**AVIUM PROJECTS PTY LTD**

**MATER MARIA COLLEGE  
5 FOREST ROAD, WARRIEWOOD NSW**

**S96 ACCESS REVIEW**

3<sup>rd</sup> July 2017

### 6.1. Level 1

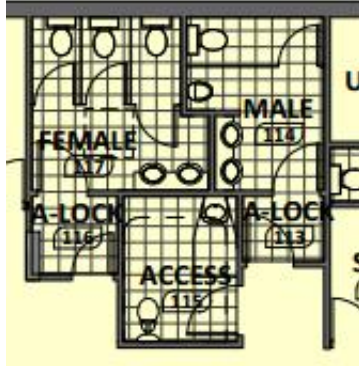
There is a bank of toilets at the northern end of Level 1 that has a unisex accessible toilet and separate male and female facilities. An ambulant cubicle will be provided in each of the male and female facilities. The provision of sanitary facilities satisfies the requirement of Part F2.4 of the BCA.

- (i) Provide details at CC showing sufficient dimensional spaces and fittings.

### 6.2. Level 2

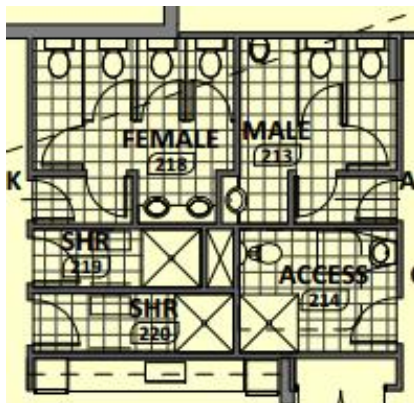
There is a bank of toilets in the centre of Level 2 that has a unisex accessible toilet and separate male and female facilities. An ambulant cubicle will be provided in each of the male and female facilities. The provision of sanitary facilities satisfies the requirement of Part F2.4 of the BCA.

The bank includes showers, including an accessible shower in the unisex accessible facility.

- (ii) Provide details at CC showing sufficient dimensional spaces and fittings.
